**Approval no: DEV2017/864**

### **CARSELDINE URBAN VILLAGE - STAGE S RESPONSE TO FURTHER ISSUES - TRAFFIC MATTERS**

CARSELDINE URBAN VILLAGE -  
STAGE S

Figure 1-4 Fitzgibbon Development Scheme

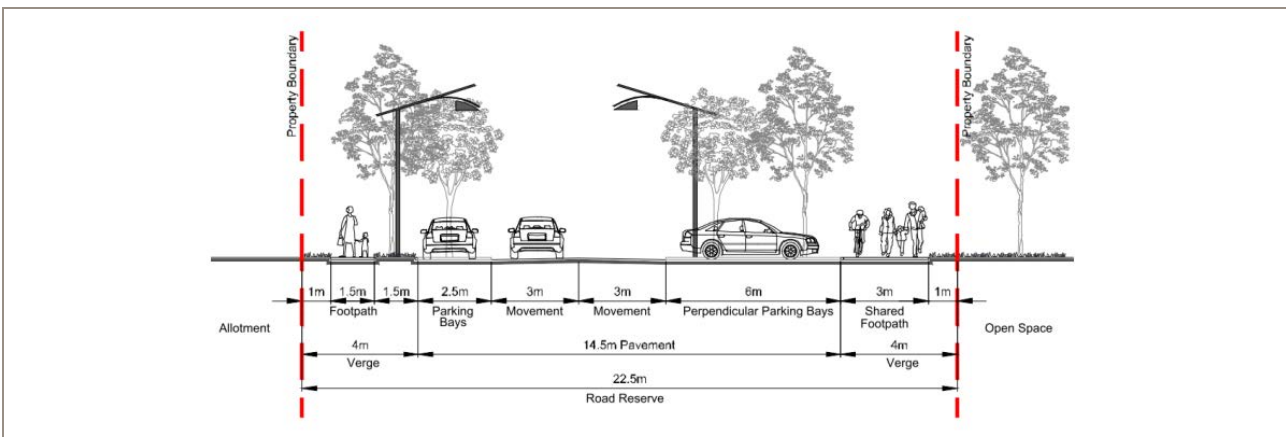
Confirm proposed road designs are compliant with the design standards contained in the Fitzgibbon Development Scheme; Cardno TIA and the Calibre Engineering Services Report indicate different functional layouts for the east-west road adjoining the park. Please ensure all technical reports are consistent and show the same layouts.

The east-west road adjoining the park is classified as a Residential Park Esplanade in the Fitzgibbon Development Scheme. The Development Scheme identifies the road reserve width as 21m however the cross section indicates that the road components add up to 22.5m. This is illustrated on Figure 1-4.

The Cardno TIA presented the cross sections prepared by RPS. This proposed a generally consistent cross section with that outlined in the Development Scheme, however with a slight change to the multi-use/shared path width from 4m to 3m with a 1m landscaped strip. Overall, the road reserve width (22.5m) is consistent with the Development Scheme. The proposed cross section is outlined in Figure 1-5.

The deviation from the Development Scheme is considered to be minor and consistent with the intent of the proposed road corridor. The provision of a 3.0m wide shared path is consistent with Austroads guidance for path widths, which indicates a range of 3.0m to 4.0m for recreational paths.

Figure 1-6 Comparison of On-street Parking Design

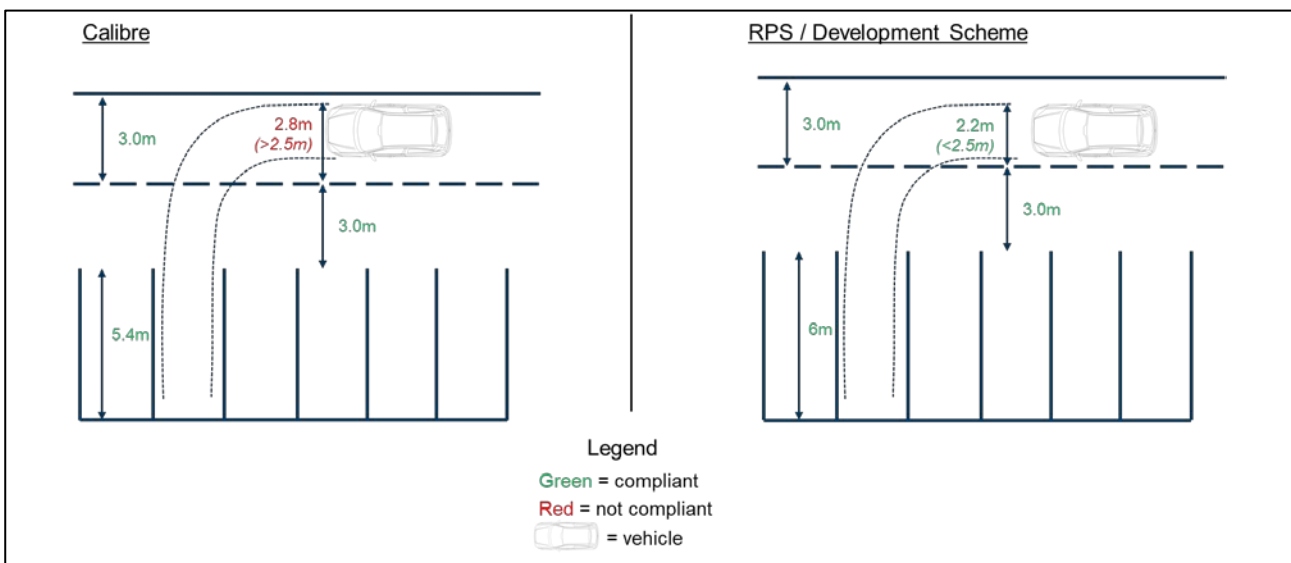
The difference between the Calibre and RPS designs is illustrated in Figure 1-6.

The Calibre design allows for 5.8m manoeuvring space as per the standard, however this requires encroachment of 2.8m into the adjacent travel lane which is greater than the allowable 2.5m.

The RPS and Development Scheme designs provides an additional 0.6m manoeuvring space with the provision of 6m long bays, allowing for 2.2m encroachment into the adjacent lane, which is in accordance with AS2890.5. However, it is noted that the additional 600mm length provided within the bays should be allocated as road space to avoid the situation where vehicles park up to the edge of the space, minimising the manoeuvring space possible for other vehicles.

Figure 1-7 Recommendation for On-Street Parking Design

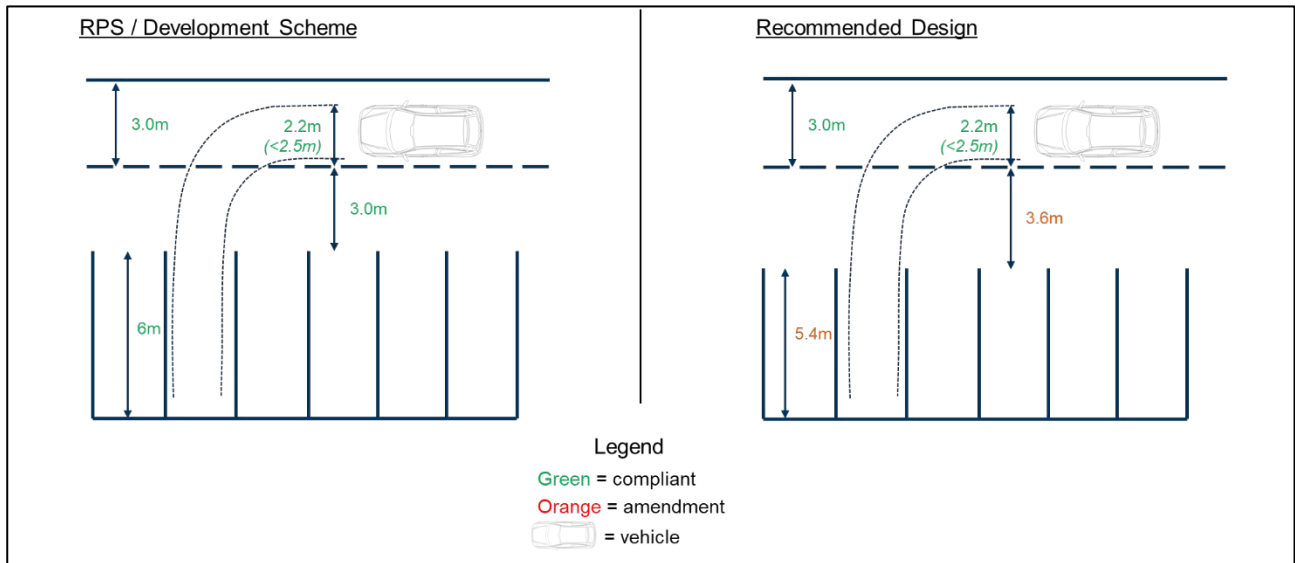
Therefore, Cardno recommends the following amendments be made to the final design of the road:

- > space length of 5.4m
- > 3.6m travel lane width for lane immediately adjacent to parking, this is an increase of 0.6m from the Development Scheme, RPS and Calibre designs.

This is illustrated on Figure 1-7. While these changes differ from the Development Scheme design and the RPS design, it maintains compliance with the AS2890.5 for on-street parking.

Therefore, the recommended changes to the cross section outlined in Figure 1-7 are proposed to override the RPS design and the Development Scheme design to ensure compliance with Australian Standards. The differences between the designs have been resolved to align with the recommended design to override the Development Scheme as an acceptable solution. This has been reflected in the updated RPS design.

Drawn T.Anang	Date 19/03/2017	Scale 1:500	Size A3
Drawing Number CEB06857 - SK07			Revision D

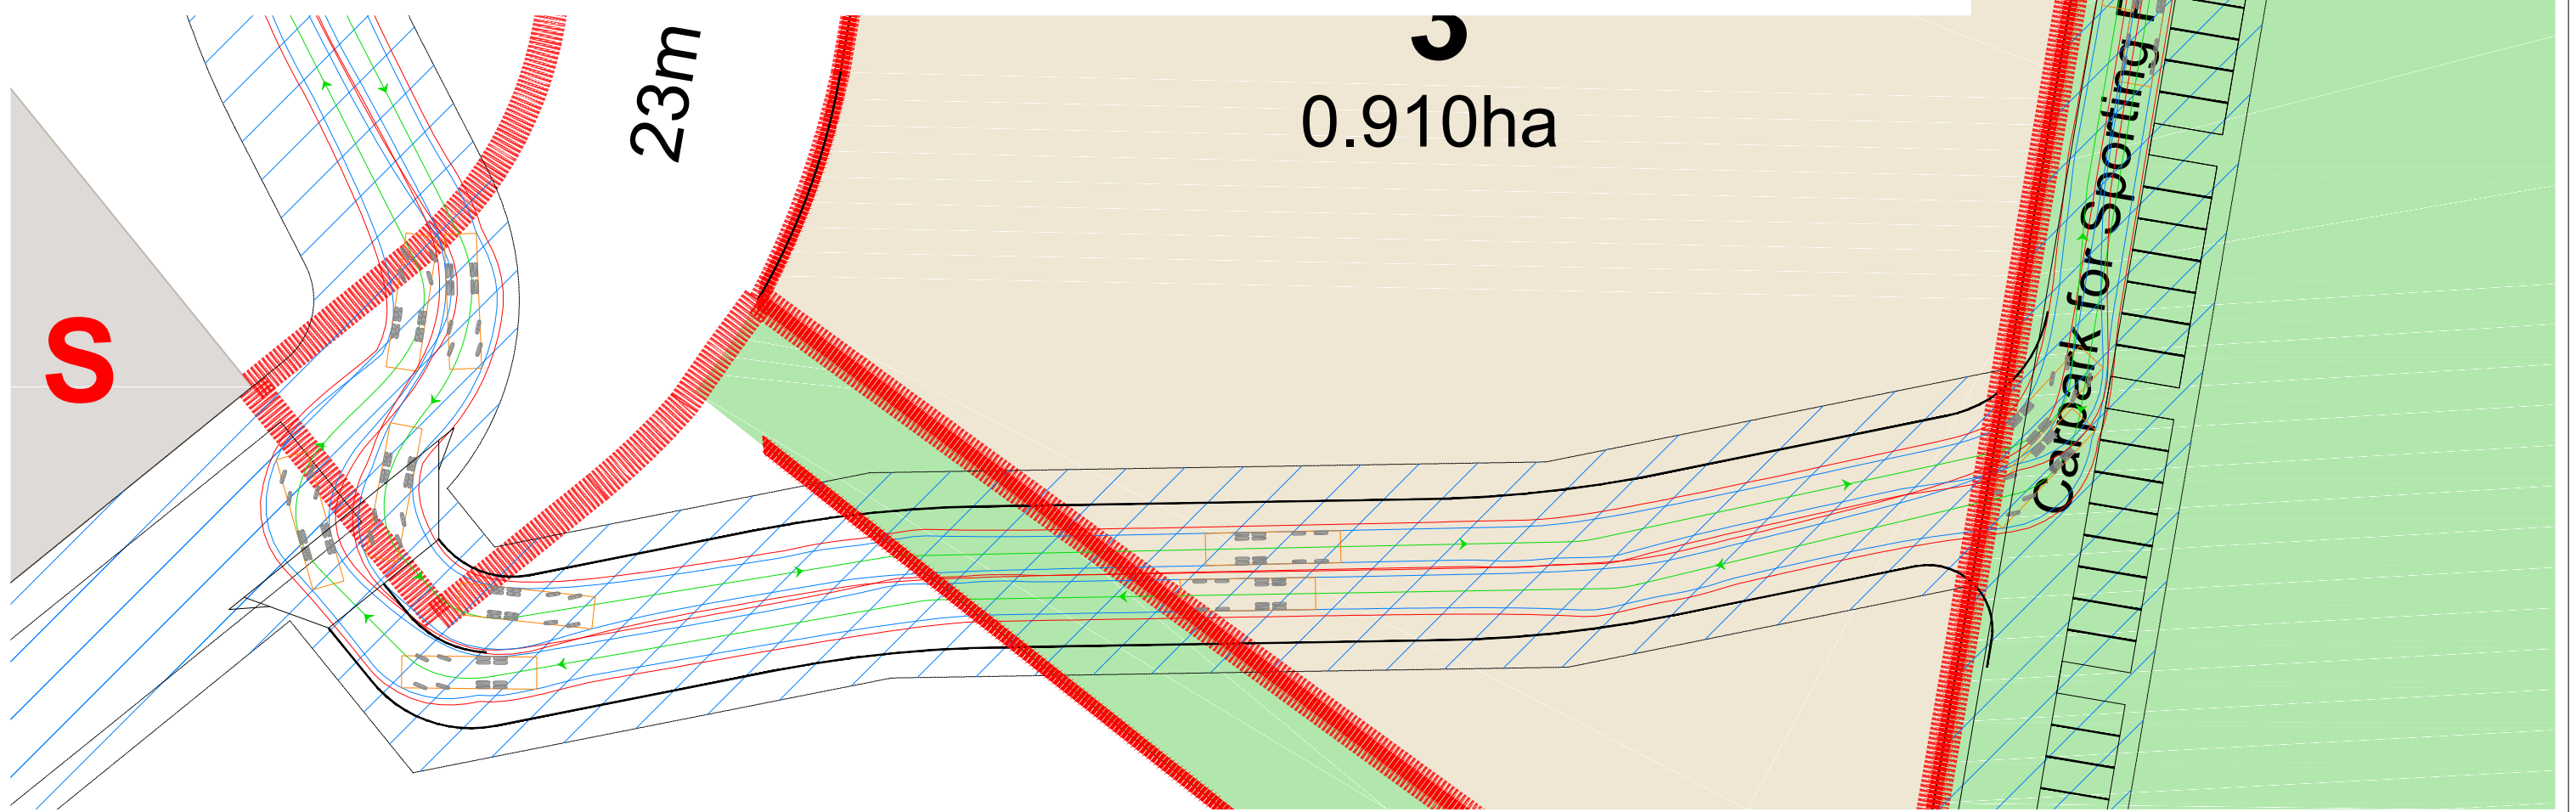
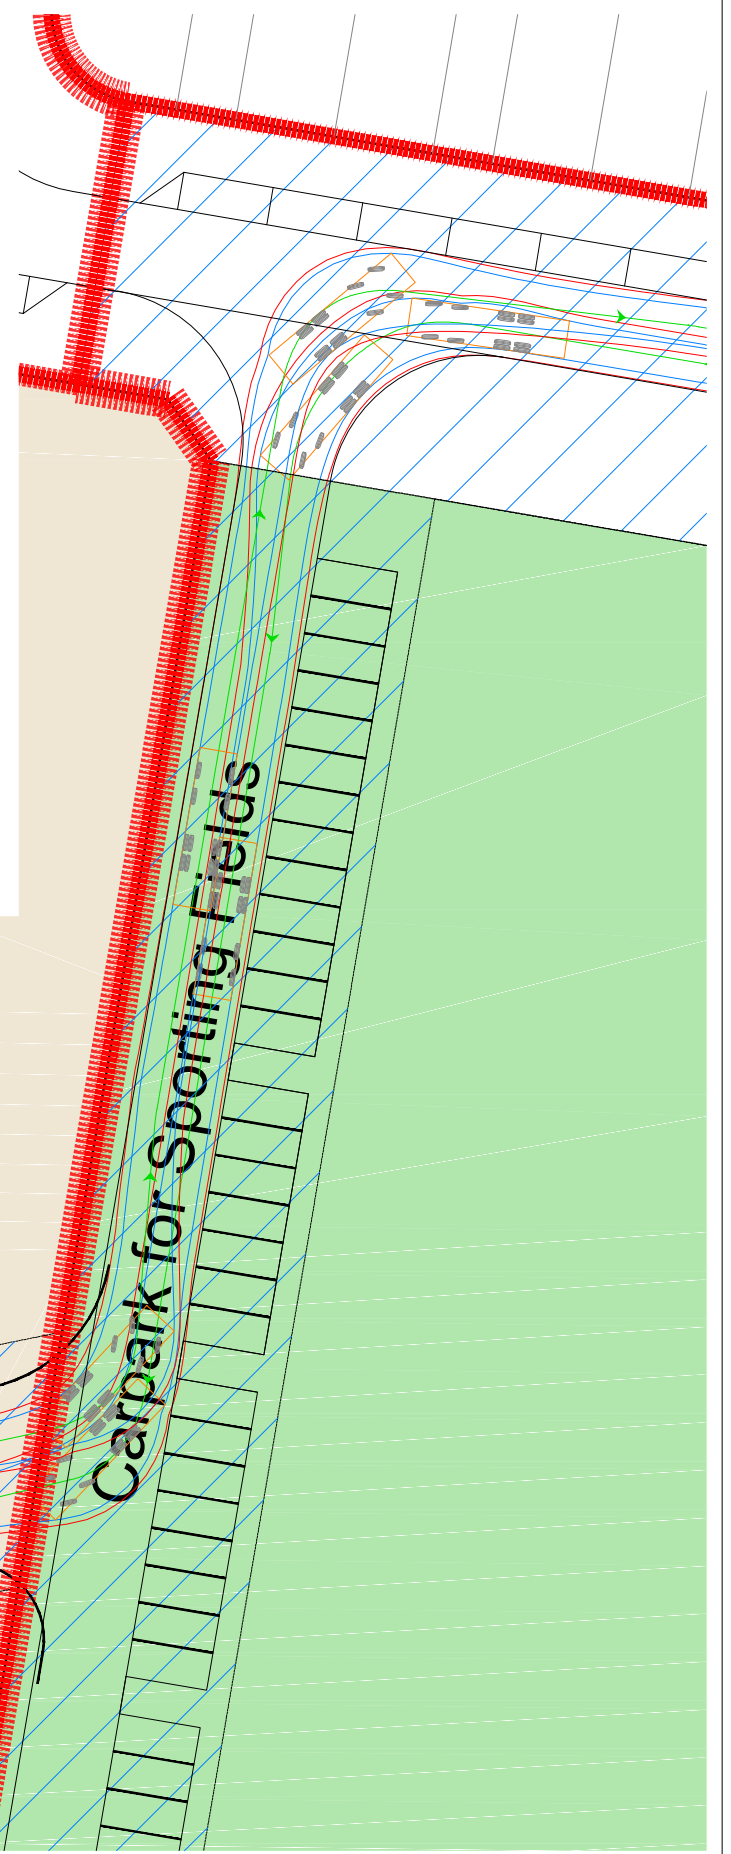
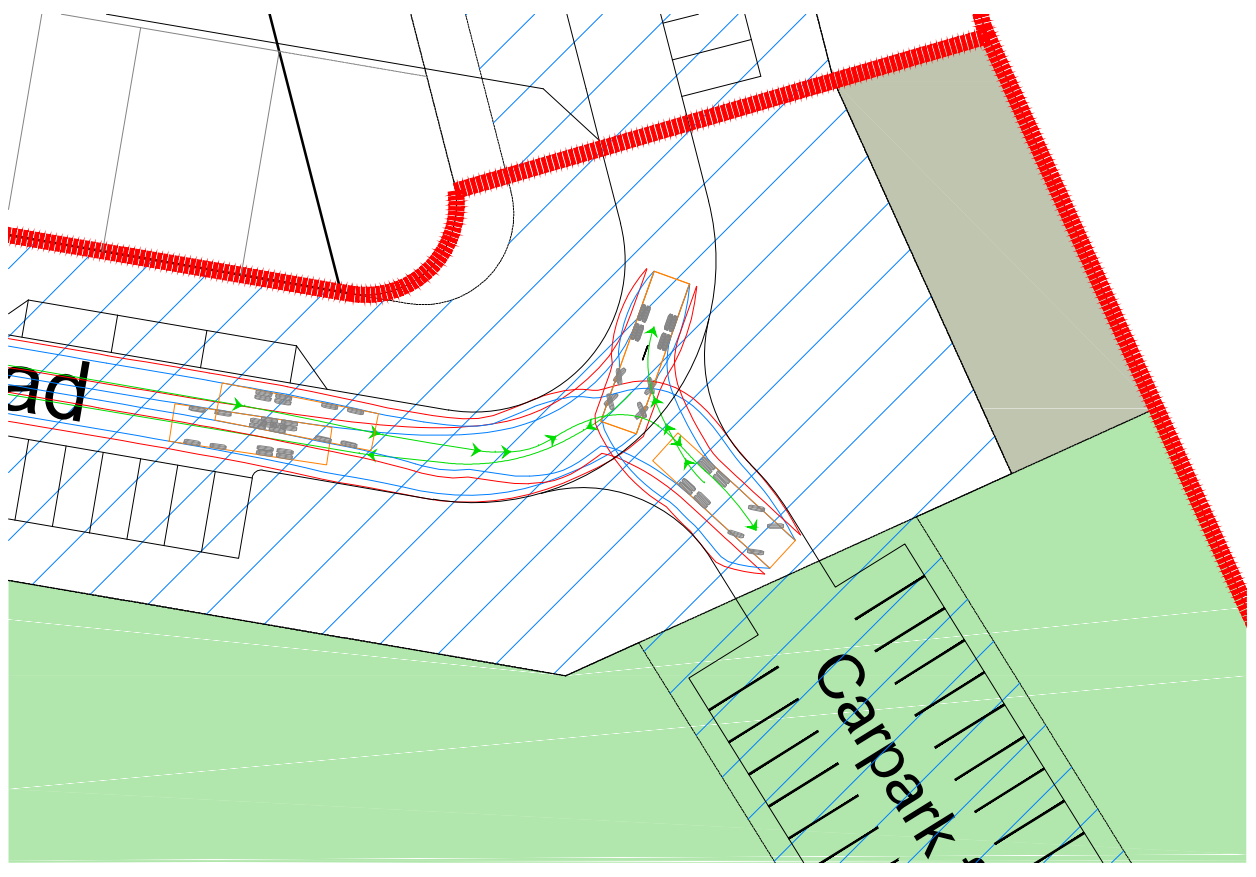
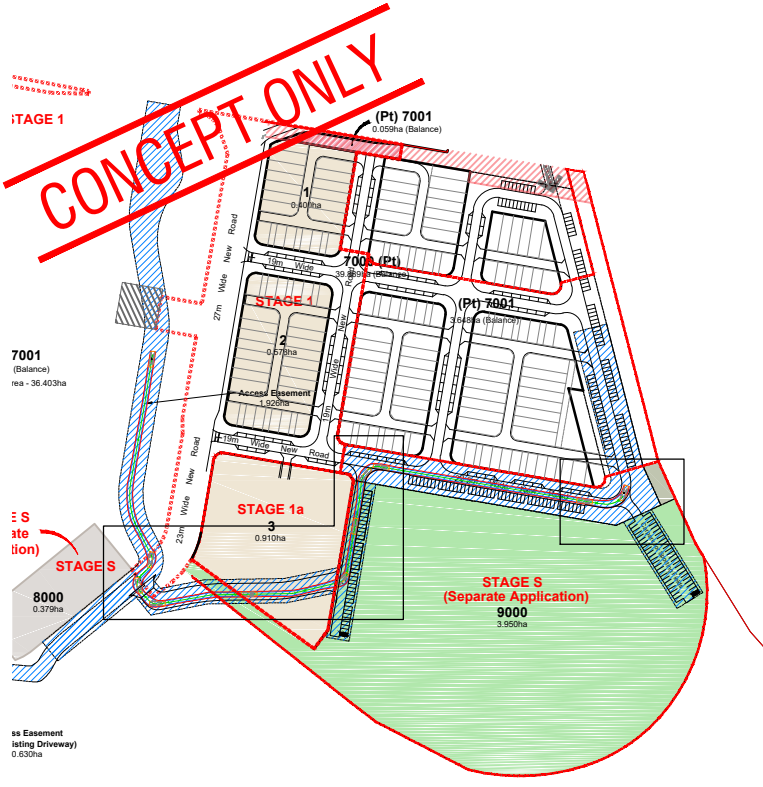
A swept path assessment has been completed for a BCC standard RCV, which demonstrates that the service vehicle can enter/ exit in a forward motion, and manoeuvre safely and efficiently through the site. Refer to drawing CEB06857-SK07-D. It is illustrated that the site is able to be safely serviced by an RCV.
